WOODSIDE SUBDIVISION, UNIT EIGHT

APPLICATION NUMBER 21 DATE June 16, 2005
APPLICANT Woodside Subdivision, Unit Eight
REQUEST Subdivision

DETAIL SITE PLAN

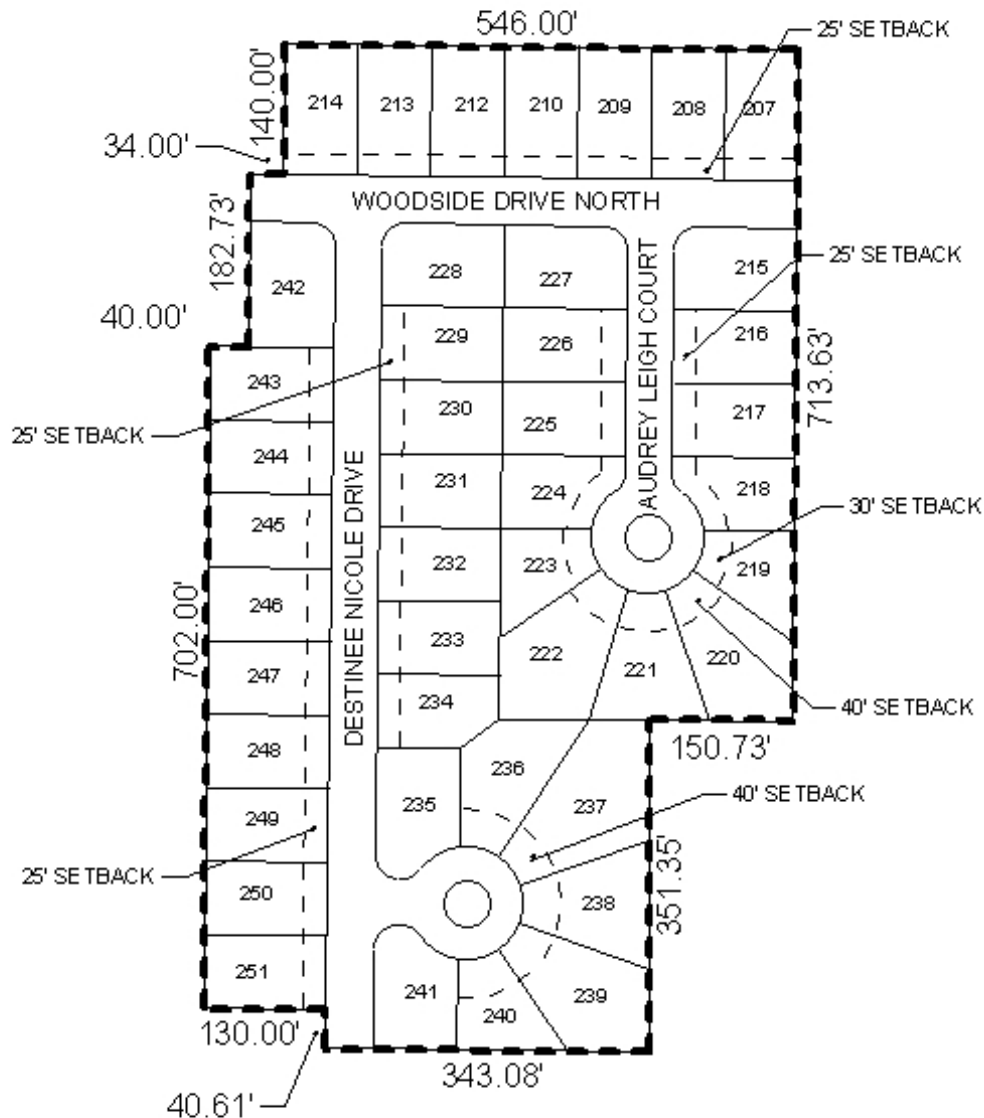
The site extends west from Woodside Drive North, which has a 50' right-of-way. The application involves the creation of new streets, which should be constructed and dedicated. The site abuts a large, undeveloped, landlocked parcel to the East, which is currently used as a borrow pit and is owned by another party; while there is an access easement to the parcel, a street stub to the East should nevertheless be provided, in accordance with Section V.B.1 of the Subdivision Regulations.

The required 25' minimum building setbacks are shown for most lots, but are not shown for corner lots; these lots should be illustrated with 25' setbacks, as required by the Subdivision Regulations.

Common areas are shown on the plat; thus a note should be required on the final plat stating that maintenance of the common areas shall be the responsibility of the property owners.

Detention is not shown on the plat; any detention areas should be labeled as such, and a note should be required on the final plat stating that maintenance of detention facilities shall be the responsibility of the property owners.

The plat meets the minimum requirements of the Subdivision Regulations and is recommended for Tentative Approval, subject to the following conditions: 1) the construction and dedication of the new streets; 2) the provision of a street stub to the undeveloped parcel to the East; 3) the illustration of the 25' minimum building setbacks; 4) the placement of a note on the final plat stating that maintenance of common areas shall be the responsibility of the property owners; 5) the labeling of any detention areas and the placement of a note on the final plat stating that the maintenance of detention facilities shall be the responsibility of the property owners; and 6) the placement of a note on the final plat stating that any lots that are developed commercially and adjoin residentially developed property must provide a buffer, in compliance with Section V.A.7 of the Subdivision Regulations.
